UNITED STATES PATENT AND TRADEMARK OFFICE

APPLICATION NO.	FILING DATE	FIRST NAMED INVENTOR	ATTORNEY DOCKET NO.	CONFIRMATION NO.
09/960,615	09/21/2001	Joseph Yoder	61773.02101	7143

Office Action Summary

DETAILED ACTION

Arrays/webs generally upstanding
(Polisena)

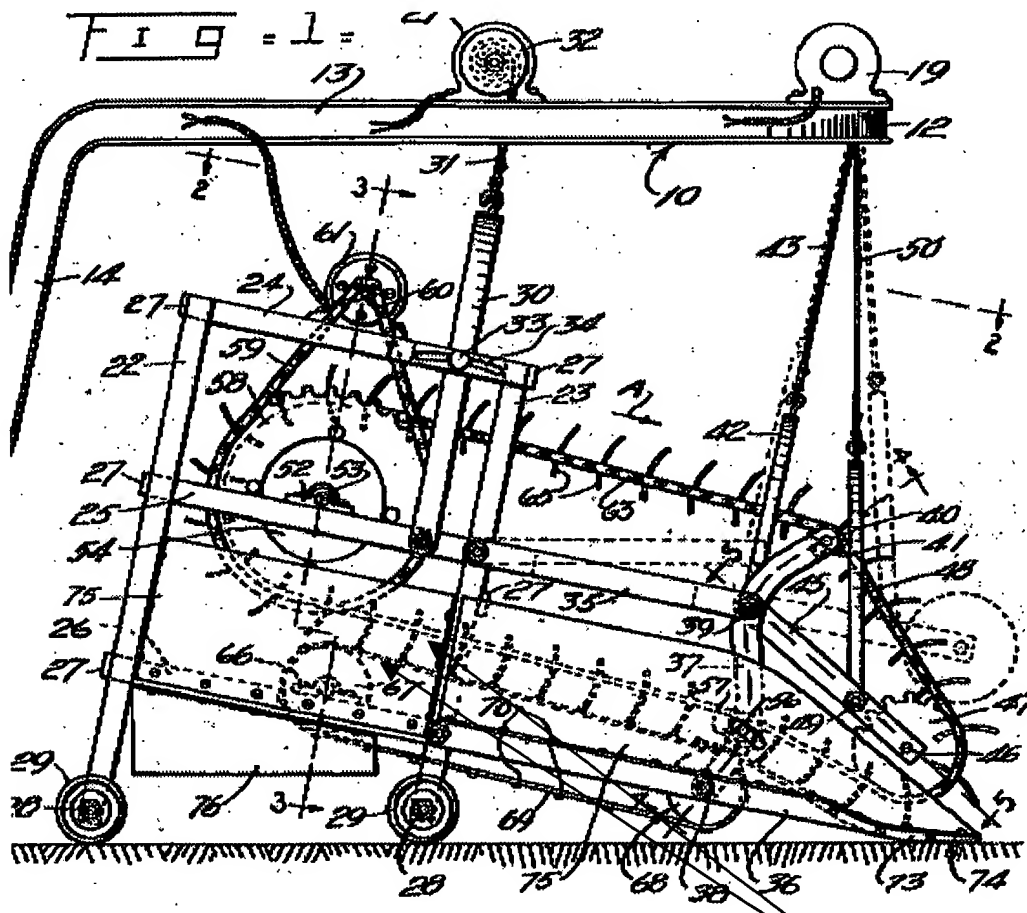
Applicant's argument in re claims 1, 13, 34, 35, that the arrays/webs are not upstanding in the cited prior art is not agreed with, because as shown below the arrays & webs are indeed generally upstanding as claimed.
